Re: POLYFLOW MANUFACURING
10800 Gibson Avenue SE
Approval of Permanent Certificate of Occupancy (C.O.)
Engineer's Stamp dated 12/09/2006 (M-21/D7A1)
Certification dated 10/06/2005

RE: Ktech Polyflow manufacturing as built Grading and drainage plan

Re: POLYFLOW MANUFACTURING (M-21/D7A1)
10800 Gibson Blvd. SE
Request for Permanent Certificate of Occupancy (C.O.)

RE: Polyflow Manufacturing, Grading and Drainage plan and report
Engineer's stamp dated 6-02-05 (M21-D7A1)

Grading Plan

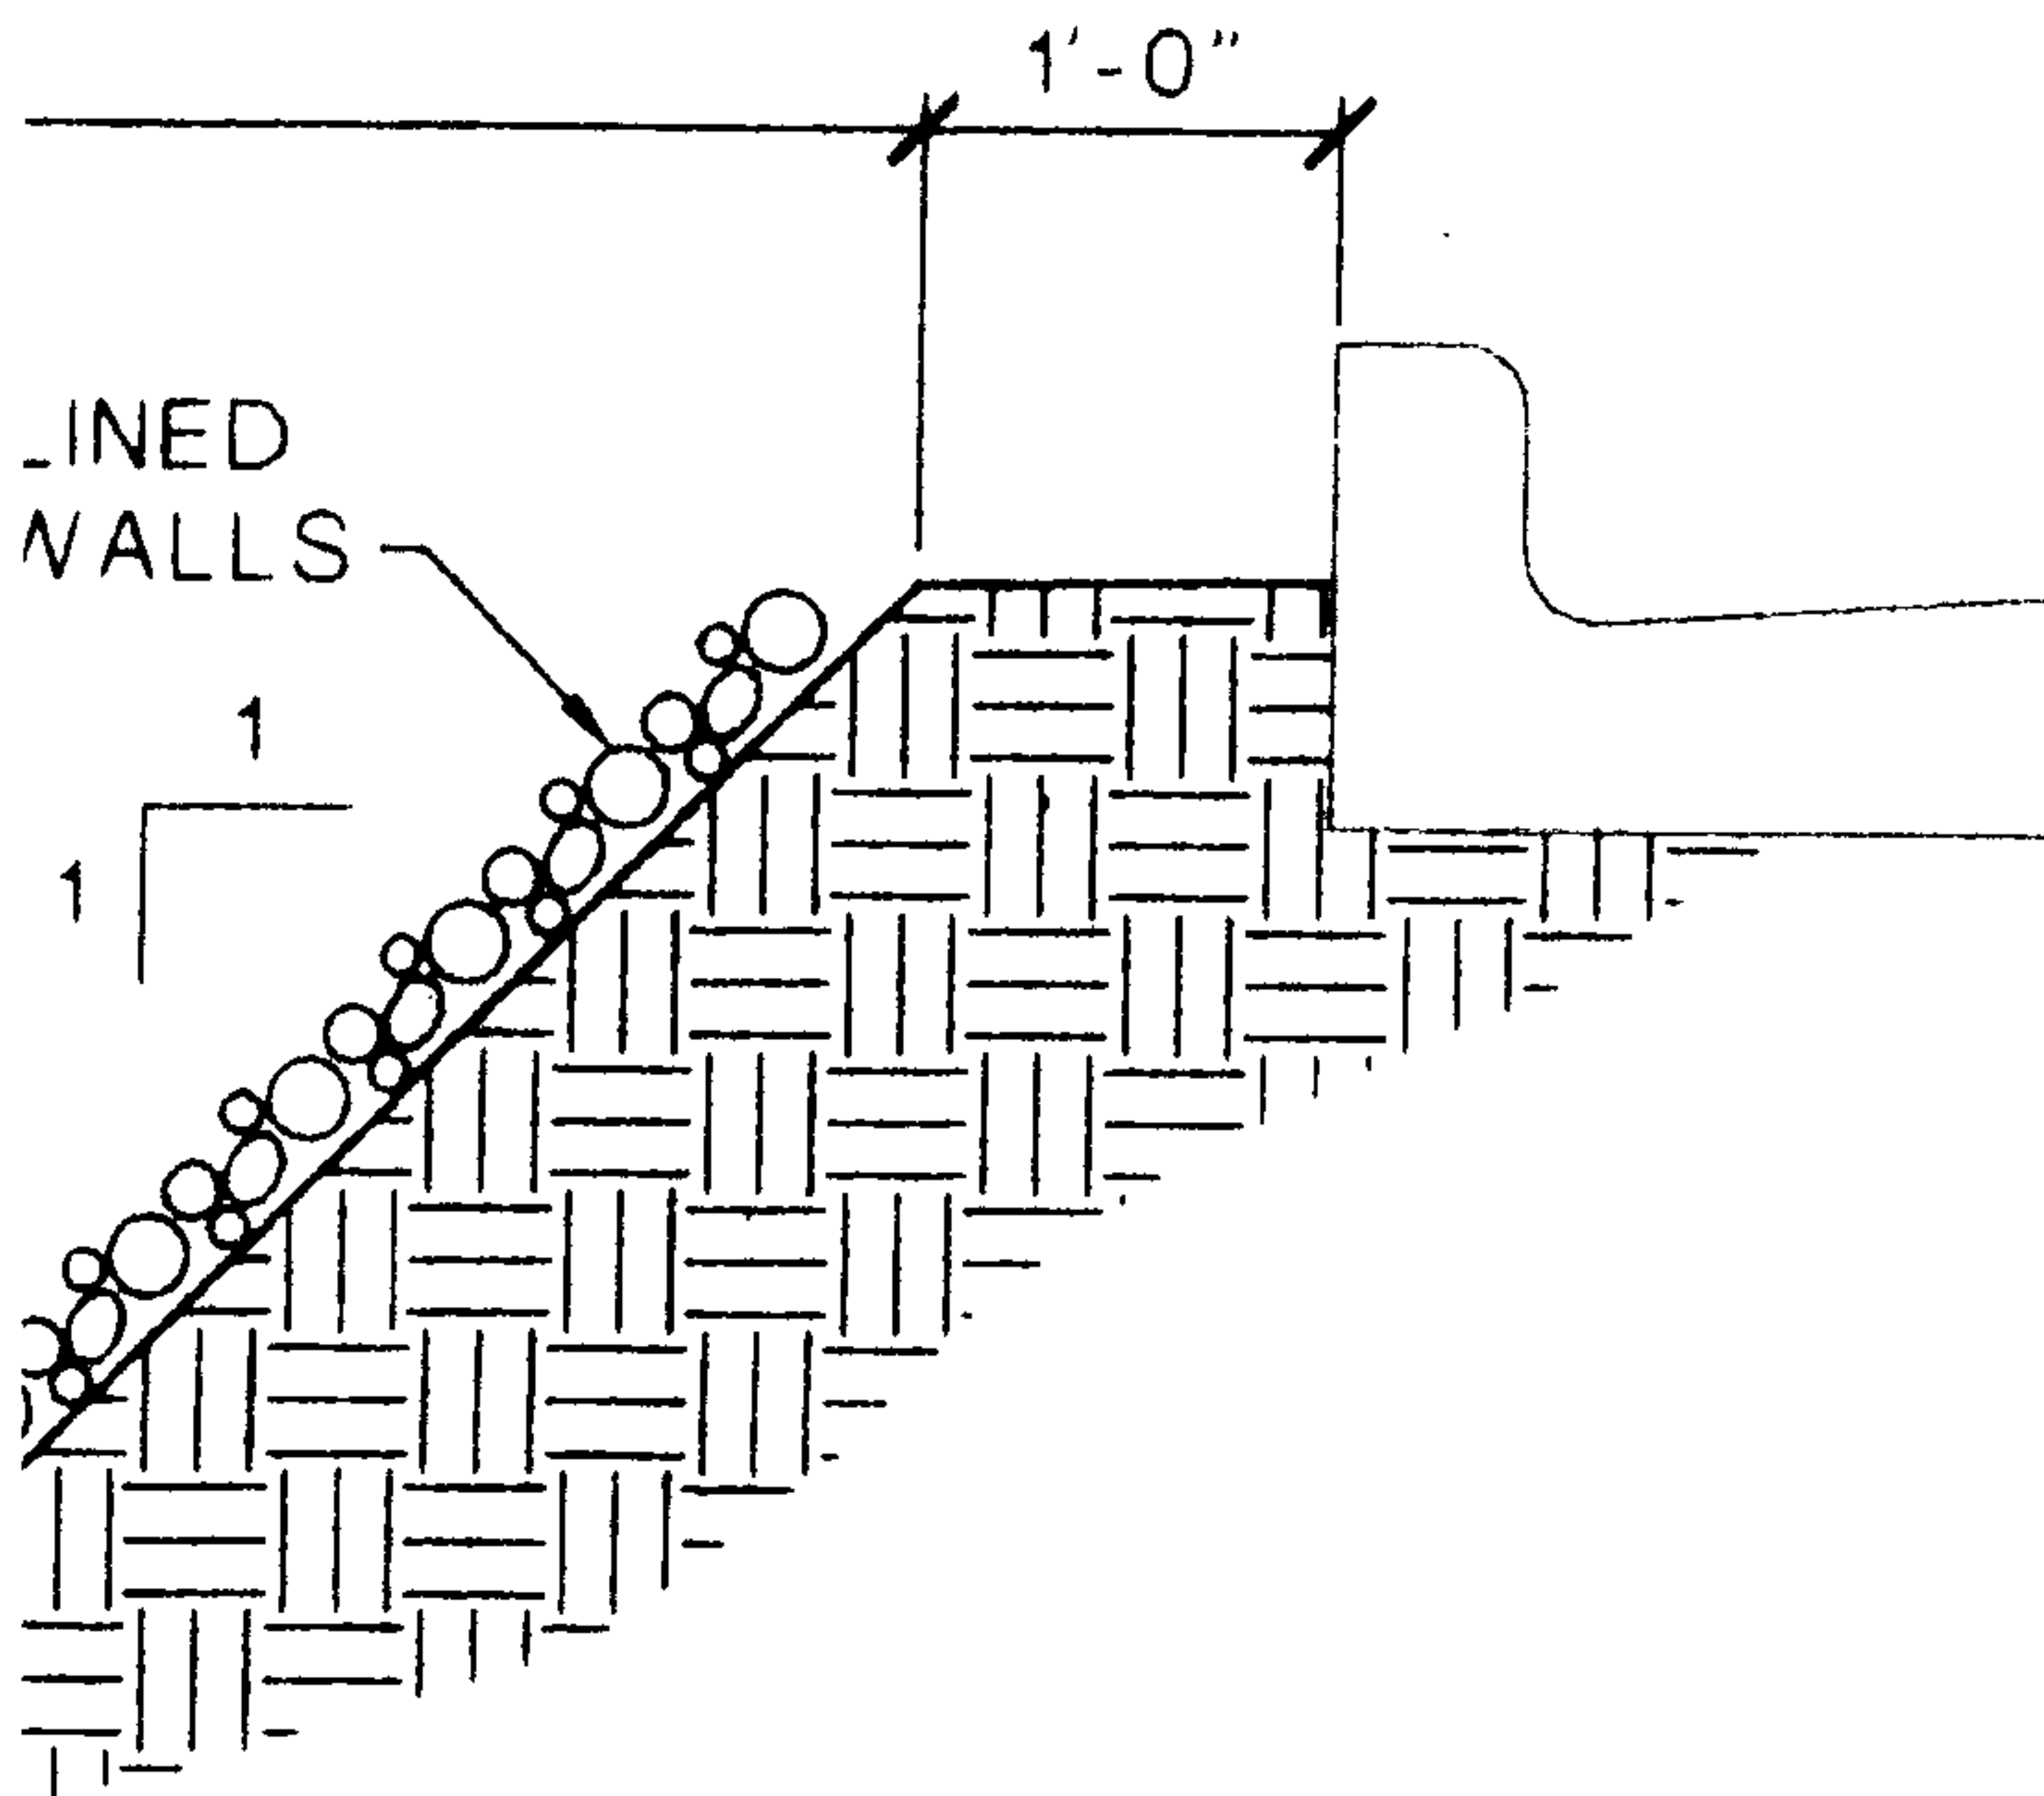
1. **The edge of curb cannot be at a higher elevation than the retaining wall. Extend the retaining wall to the same elevation, and place fill in between the curb and the wall.**

- ✓ 2. **Specify the size of the proposed curb cuts.**
The dimensions for the curb cuts have been added to the plan.

3. **Since ponds 1 and 2 are not connected, please specify the quantity of flow that enters each pond.**

- ✓ 4. **Why are no calculations shown for pond 3?**
Pond 3 was considered as part of pond 1 due to the connection with the 12" cmp. The plan has been re-labeled.

5. **Provide inverts for all propose drainage structures.**
Inverts have been added.

- ✓ 6. **The sump drains, located at each dock, appear to connect to storm drain. Please specify the size of these storm drains, as well as inverts and outfall information.**

8. **The pond detail refers to the width of the pond as "varies". Please provide more information.**

The retaining walls have been removed and replaced with a rock slope. The grading as shown on the revised plan should work.

The flow to each pond is identified in the drainage report.

The sump drains will connect to a drain line that will daylight into the landscaped area as shown.

The ponds width varies as it follows the sidewalk. The pond capacities have been shown on the AHYMO calculations are also shown at the end of the drainage report on the pond calculation sheets.
